PROBLEM:

On early H1 and H2 models, there have been problems of gear engagement resulting from excessive play in the stationary gears on both the drive and output shafts.

SOLUTION:

A. CORRECTIVE ACTION FOR 4TH GEAR:

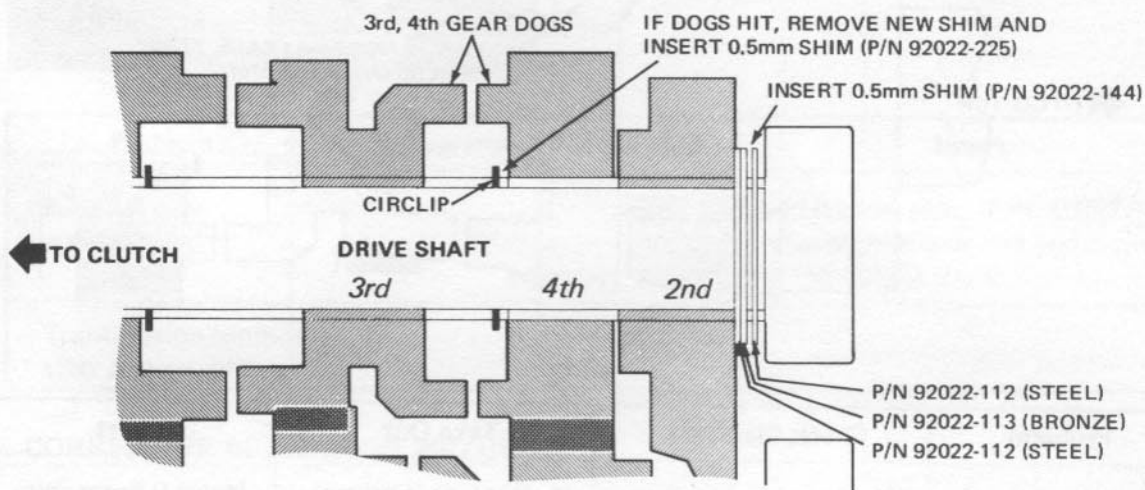
1. Insert an 0.5mm shim (P/N 92022-144) between second gear and the bearing on the drive shaft. The shim goes between the bronze and steel washers already present. This moves second and fourth gears over toward the third gear slider, making a more positive engagement of fourth. If the shaft turns hard, take the shim back out.
2. If fourth gear dogs hit third gear dogs after adding the shim, then take it back out and add a 0.5mm shim (P/N 92022-225) between 4th gear and the circlip. This keeps the sloppiness out of the gear without forcing the dogs together.

4th Gear Problem	Clearance	Take Out	Insert
Jumps out of 4th gear.			0.5mm shim (92022-144) along with shims already present between second gear and end bearing on drive shaft.
4th gear dogs hit 3rd gear dogs in neutral after adding shim.		Remove new 0.5mm shim between 2nd gear and end bearing on drive shaft.	Add 0.5mm shim (P/N 92022-225) between 4th gear and circlip on drive shaft.

B. CORRECTIVE ACTION FOR 5TH GEAR:

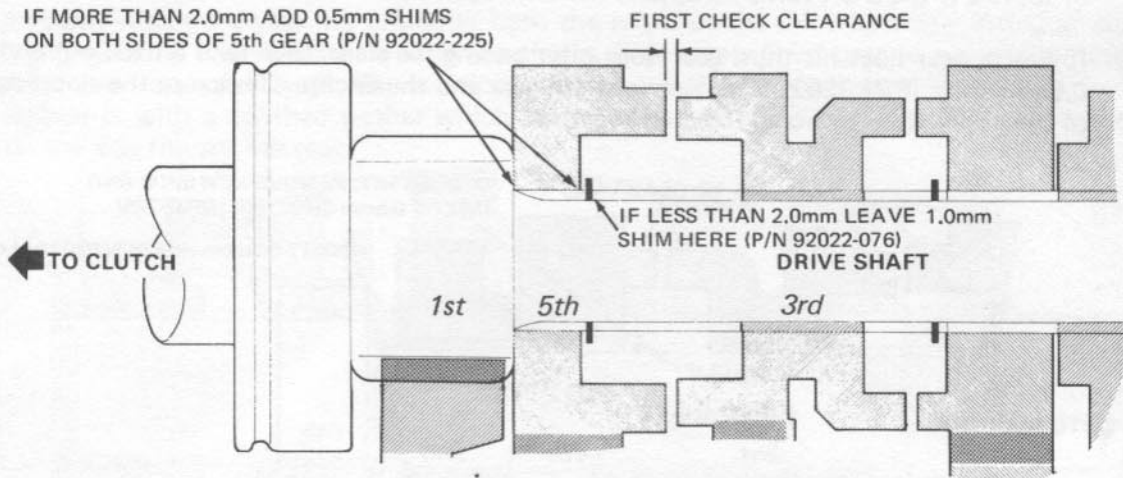
1. To eliminate jumping out of fifth gear, measure the clearance between fifth and third gear dogs on the drive shaft. If the clearance is over 2.0mm, remove the factory installed 1.0mm shim (P/N 92022-076) between fifth gear and the circlip, and add a 0.5mm (92022-225) shim on either side of fifth gear. This moves fifth gear 0.5mm closer to the slider gear, assuring a more positive engagement. If the clearance is less than 2.0mm between dogs on the two gears, then leave the 1.0mm shim where it is.

Problem	Check Clearance	Take Out	Insert
Jumping out of 5th gear.	Ck clearance between 5th and 3rd gear dogs on drive shaft.	If clearance is greater than 2.0mm take out 1.0mm shim between 5th and circlip.	Insert 0.5mm shim (P/N 92022-225) on either side of 5th gear on the drive shaft.
		If less than 2.0mm leave shim where it is.

C. CORRECTIVE ACTION FOR 1ST GEAR:

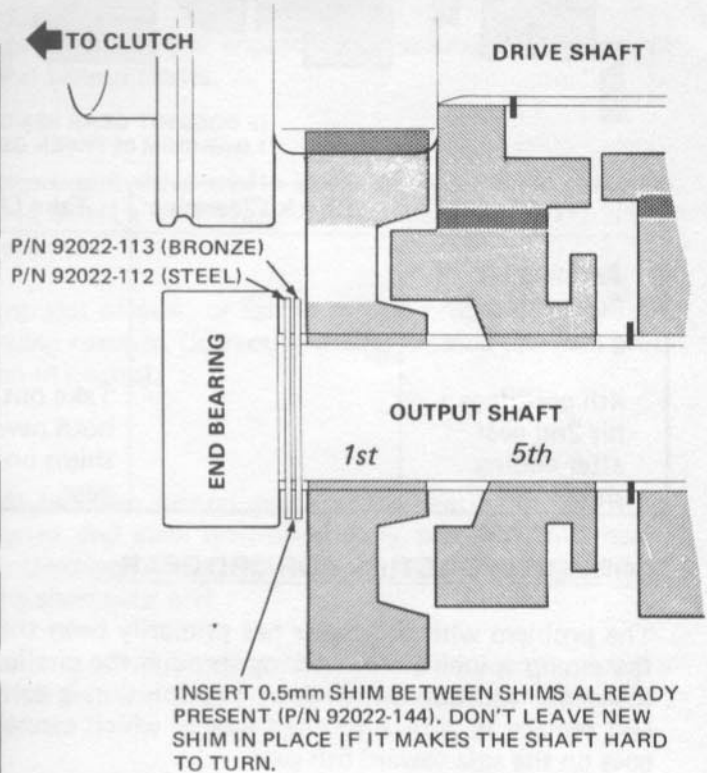
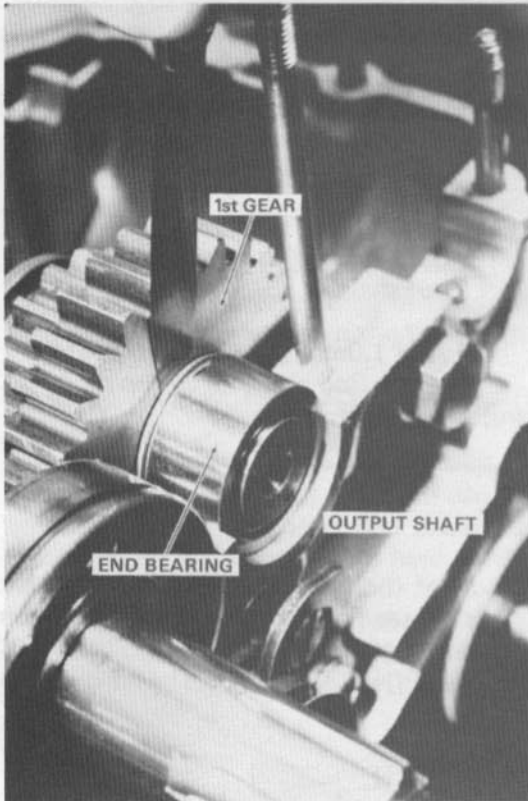
To correct poor engagement of 1st gear, insert an 0.5mm shim (P/N 92022-144) between first gear and the end bearing on the output shaft. This is in addition to the shims already present (P/N 92022-112, -113). This moves 1st gear slightly closer to the slider gear and eliminates play which may have contributed to jumping out of gear. If adding this shim makes the output shaft hard to turn, then take it back out.

Problem	Check Clearance	Take Out	Insert
Poor 1st gear engagement.			Add 0.5mm shim (P/N 92022-144) between first gear and end bearing on the output shaft.
Transmission binds after adding shim.		Take out new shims.

D. CORRECTIVE ACTION FOR 2ND GEAR:

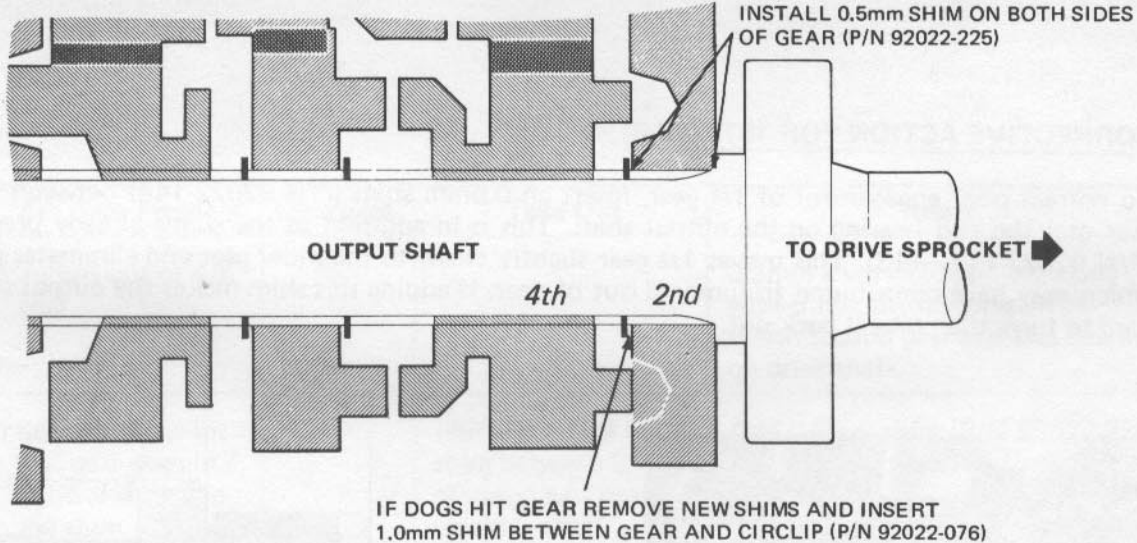
To eliminate play at second gear on the output shaft, install a 0.5mm washer (P/N 92022-225) on both sides of the gear. This moves the gear slightly closer to the fourth gear slider as well as reducing play. If the dogs on fourth gear hit second gear after the shims are added, remove both new shims and add a 1.0mm shim (92022-076) between second gear and the circlip. This will keep the dogs from hitting, while eliminating play at second gear.

Problem	Check Clearance	Take Out	Insert
Jumping out of 2nd gear.			Add 0.5mm shim (92022-225) on both sides of 2nd gear on the output shaft.
4th gear dogs hit 2nd gear after adding shims.		Take out both new shims on 2nd gear.	Add 1.0mm shim (92022-076) between 2nd gear and circlip on output shaft.

E. CORRECTIVE ACTION FOR 3RD GEAR:

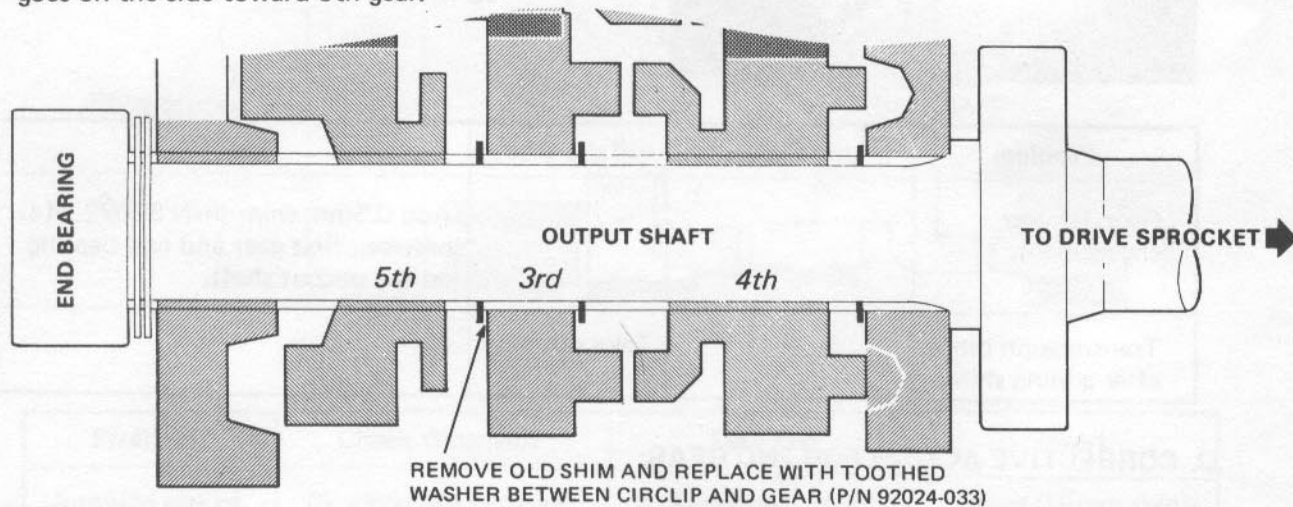
The problem with third gear has primarily been the result of the shim between 3rd gear and the circlip spinning and wearing through the circlip. This causes third gear to move away from the slider and hop out of gear. The solution is to remove the standard shim (P/N 92022-076) and replace it with a toothed washer which cannot rotate (P/N 92024-033). The new washer goes on the side toward 5th gear.

Problem	Check Clearance	Take Out	Insert
Jumps out of 3rd gear.		Remove 1.0mm shim between 3rd gear and circlip on output shaft.	Insert 1.0mm toothed thrust washer (P/N 92024-033) between 3rd gear and circlip (5th gear side).
